### **New Castle Planning and Zoning Commission Public Hearing Wednesday, March 25, 2026, 7:00 PM**

- A. Consider Resolution No. PZ 2026-3 A RESOLUTION OF THE NEW CASTLE  
PLANNING AND ZONING COMMISSION RECOMMENDING APPROVAL OF  
A CONDITIONAL USE PERMIT FOR AN ELECTRICAL SUBSTATION IN THE  
INDUSTRIAL ZONE DISTRICT**

**RE: Coal Ridge Substation  
Engineering Comments for C.U.P.**

**Planning Commission – Public Hearing**  
**Wednesday, March 25, 2026**  
**Resolution PZ 2026-3**  
**Staff Report**

**ATTACHMENT A: SITE PLAN**

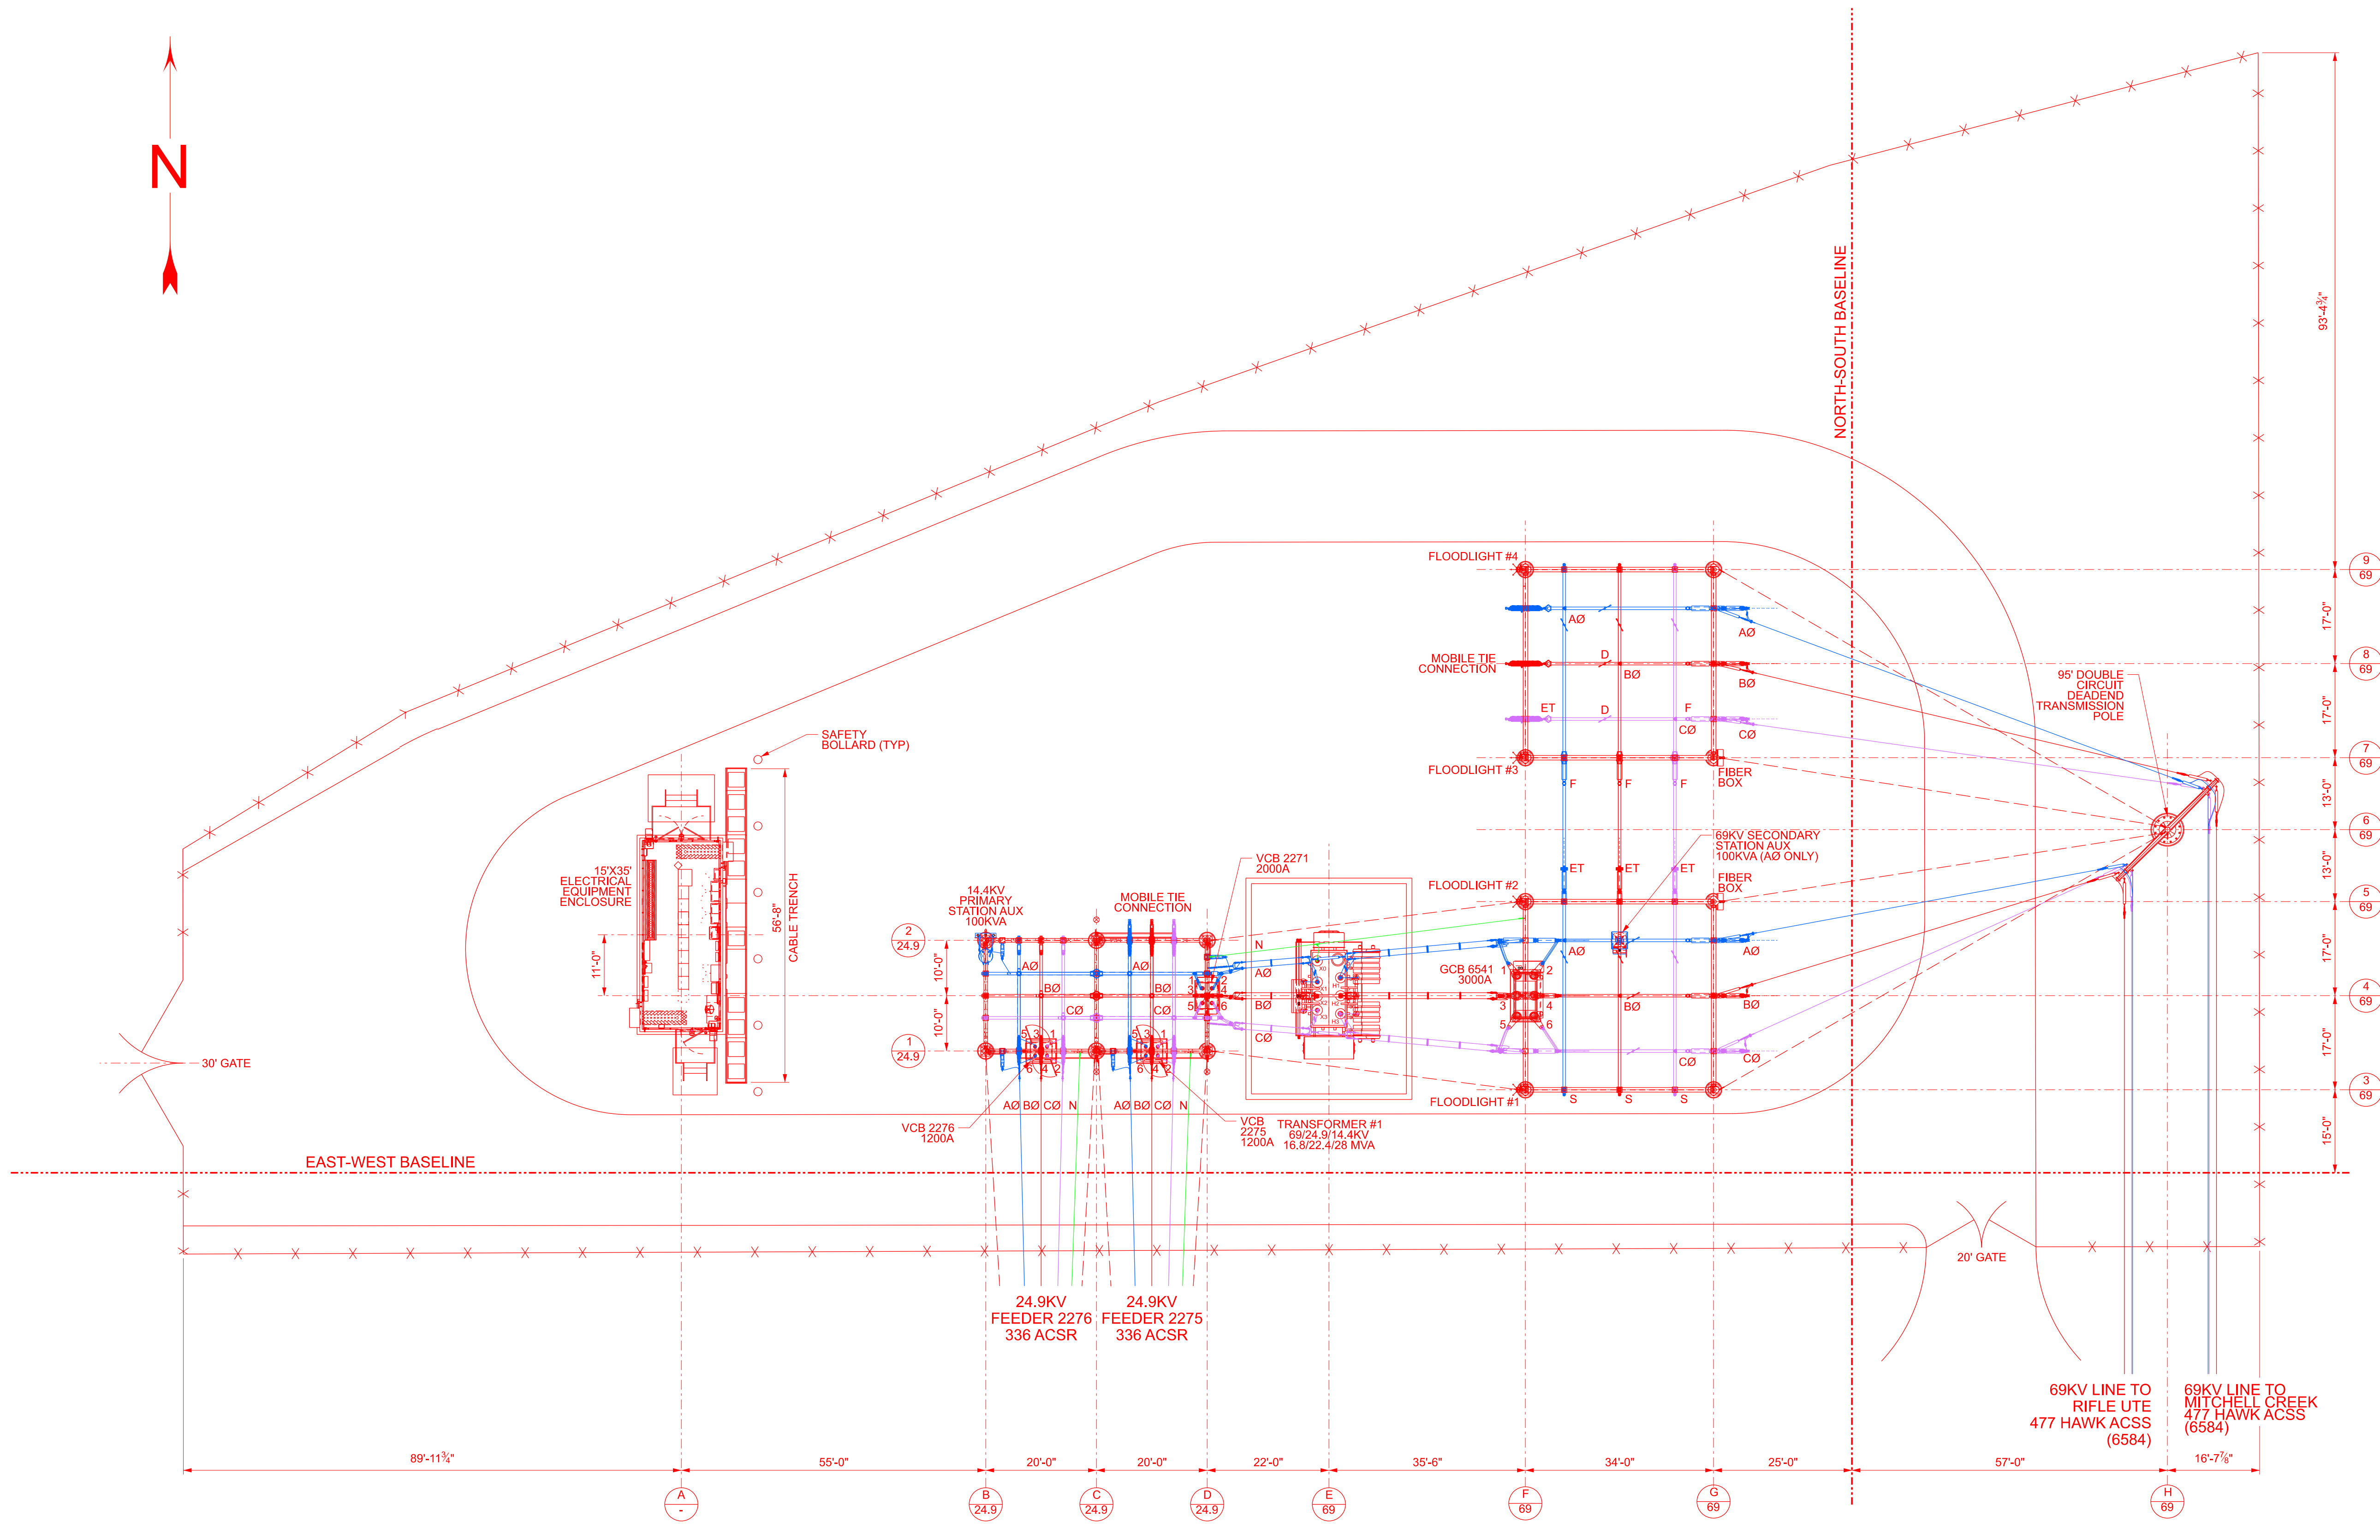
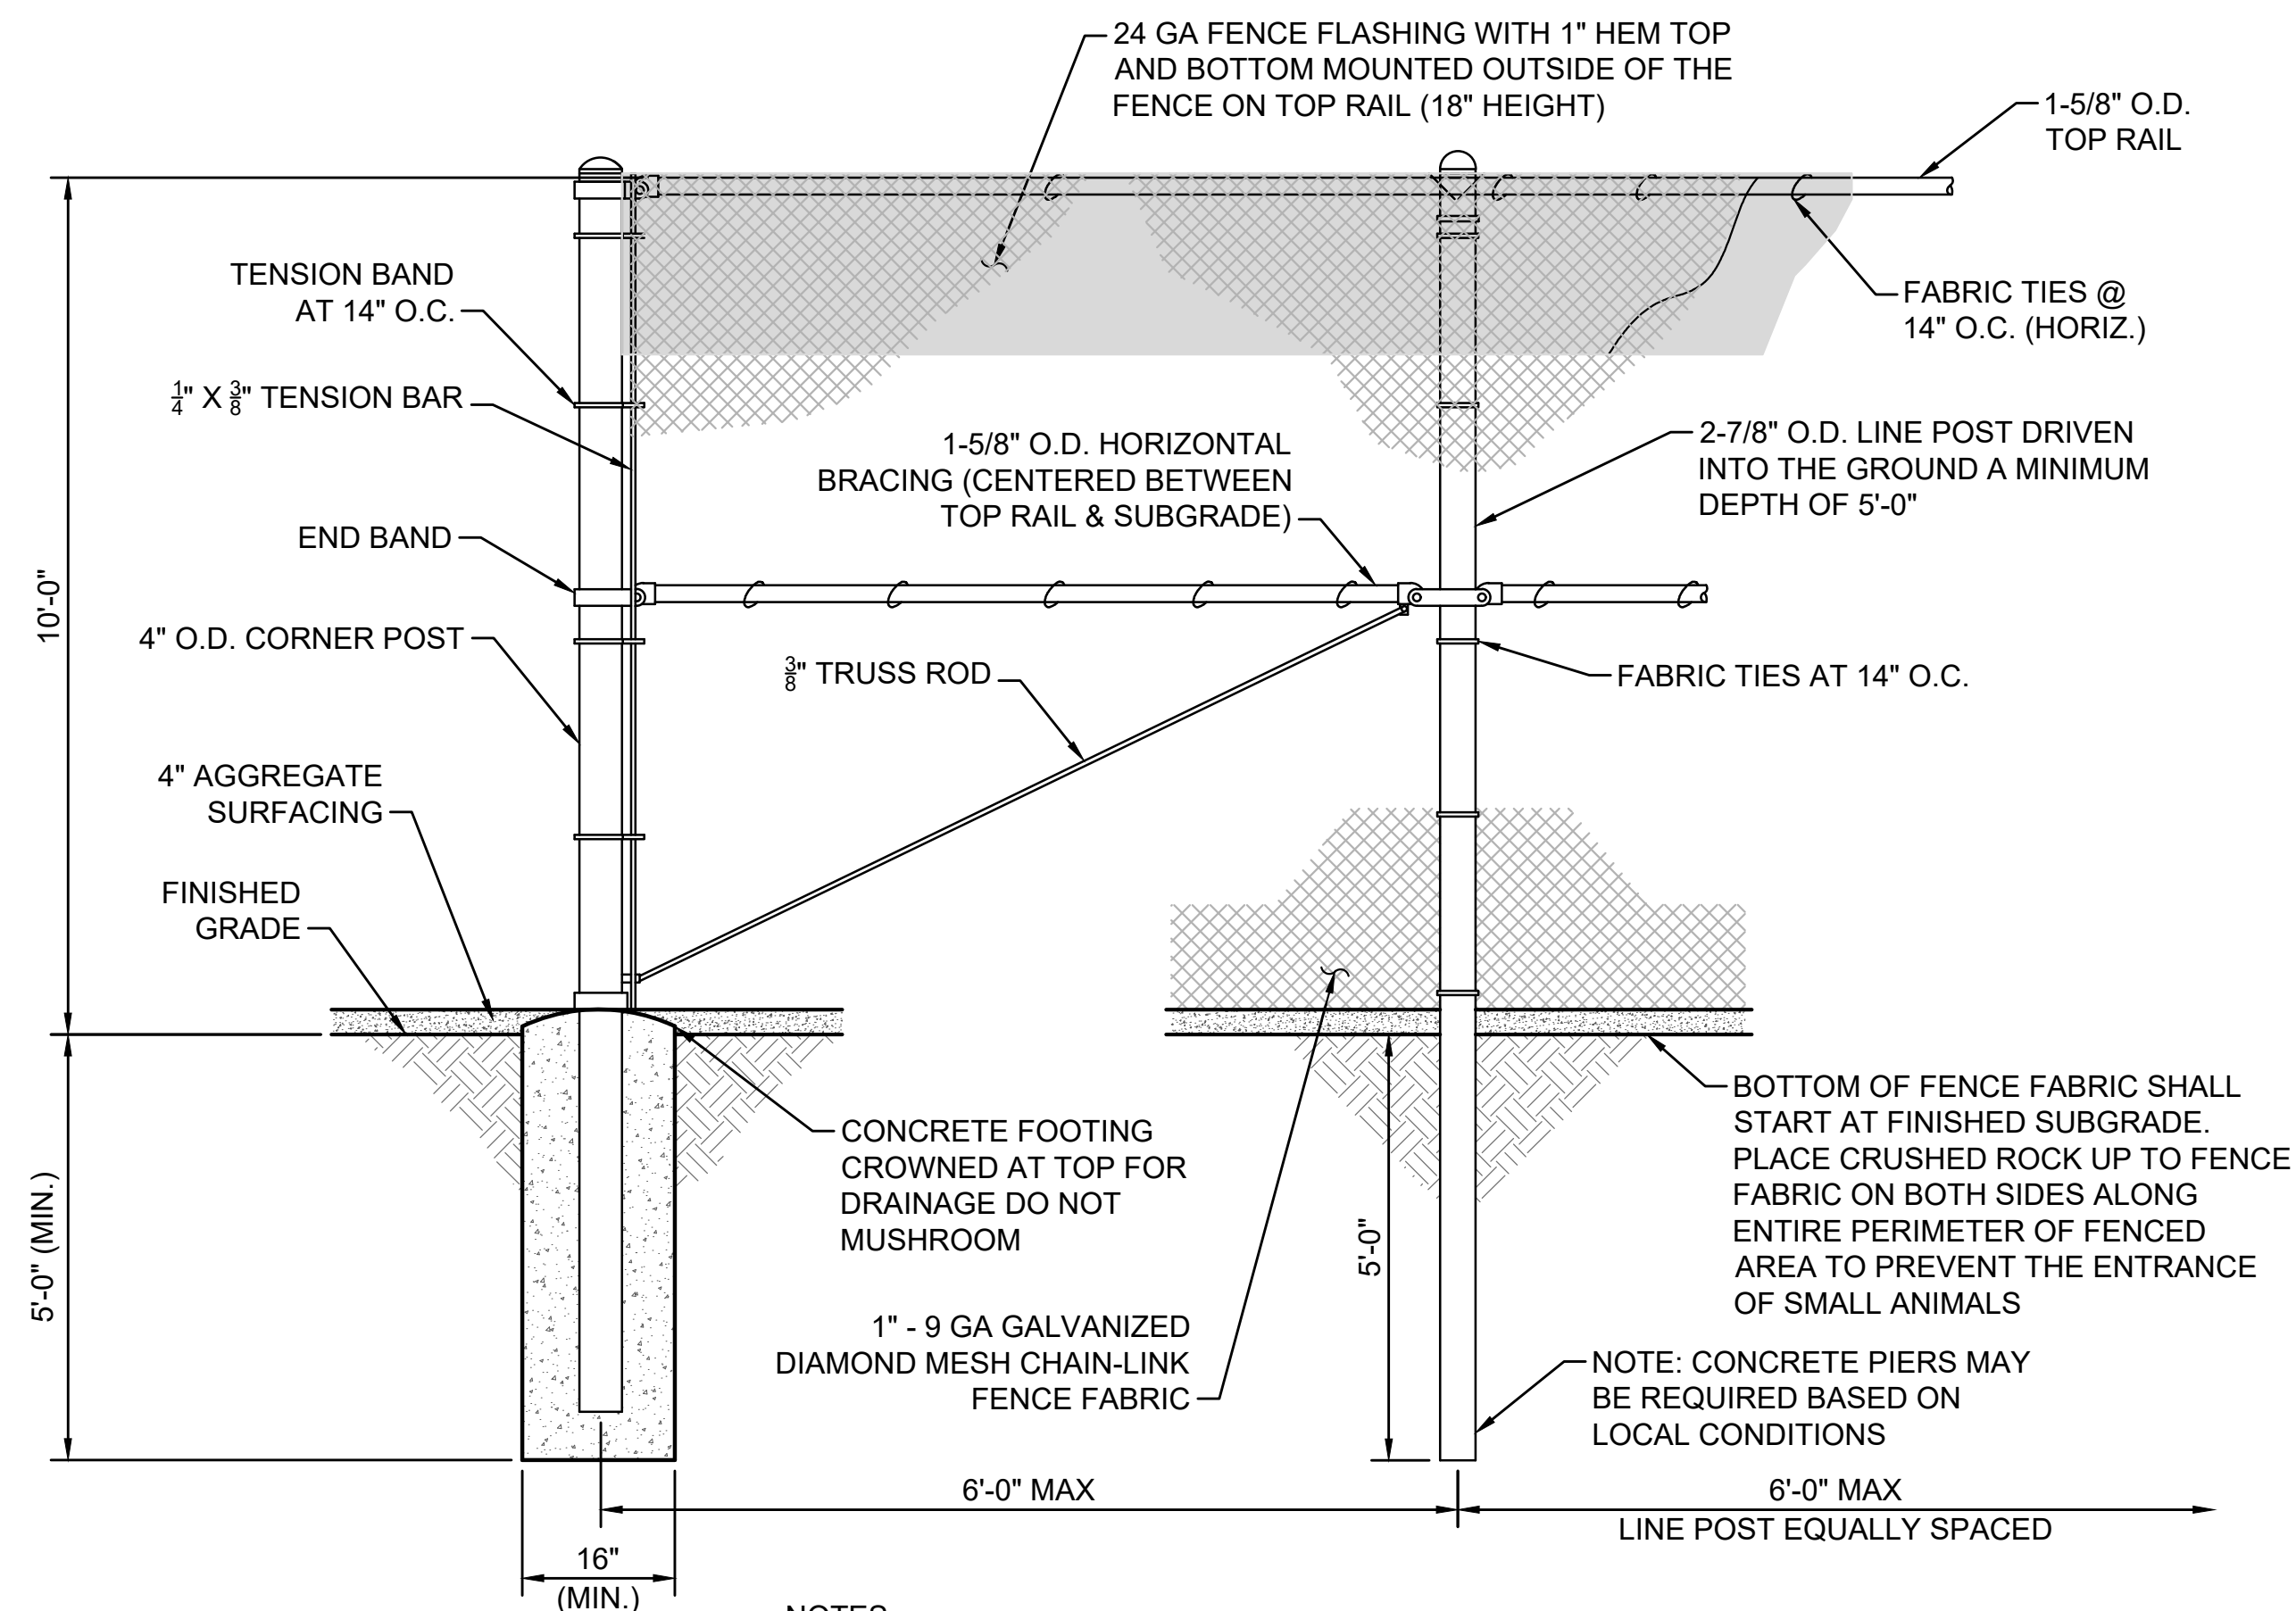
1. Prior to construction and at the time of a mandatory preconstruction meeting, provide the Town in advance for final review, a revised set of Grading, Landscaping and Construction drawings that provide construction level detail of the following:

- b. All drawings need to be stamped by a Colorado Registered Professional Engineer.
  - c. Provide details with detailed locations of guard rail placement for both temporary and final conditions.

- d. Provide specific details as to how culverts are to be installed along with details of the specific installation requirements for revetment/erosion protection of culvert inlets and outfalls.

- e. Provide specific details of final paving and how the final paving of driveways are to tie to CR 335. Provide specifications for depth of concrete, control joints, expansion joint locations, etc...
- f. Provide specific details of concrete lined swale complete with expansion and control joints. Also, provide details of inlet and culvert installations complete with pipe size, material, bedding requirement, trenching requirements and path repair details. Note that if excavating the bike path, provide saw cut joints and a 1 ½" milled 24" wide overlap of the existing asphalt at the joint when paving back the bike path final lift. Replacement depth of road base and asphalt should be 8" and two 1 ½" asphalt lifts respectfully.
- g. Provide details of all fencing, gates, etc... proposed for construction.

For the site planning and grading, please note the following that needs to be provided to the Town prior to construction:
